This Service Letter reidentified a Service Bulletin M 20-11-2 per Service Instruction M20-15.

Removal of Starter Relay Cut-out Switch

M20C, Serials 2343-2466; M20D, Serials 1, 101-160

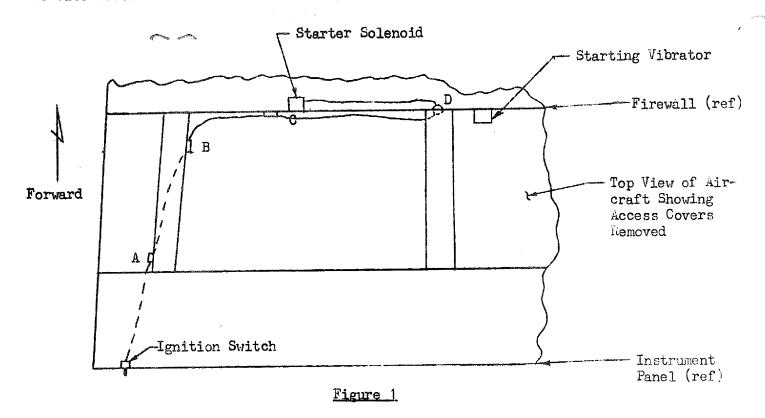
- 3. Connect wire No. 800007-188 as shown in Figure 3 on Page 2. Routing for this wire should be accomplished as shown in Figure 1 and as follows: Route new wire No. 800007-188 from "S" terminal of ignition switch with existing cables through existing clamps at locations "A" "B" and "C," through the grommet at "D" and with existing cables to starter solenoid.

- NOTE: Figure 2 shows original wiring diagram and Figure 3 shows new wiring diagram after compliance with this service letter.
- 4. Add revision sheet to Flight Manual and revised Page 6 to M20C Flight Manual or revised Page 5 to M20D Flight Manual.

Figure 3

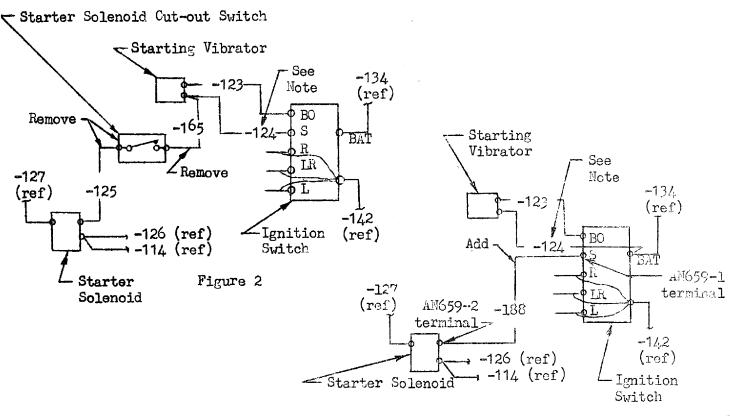
NOTE: Remove ignition switch end of -124 wire from "S" terminal and replace on "BAT" terminal. The starter vibrator end remains intact.
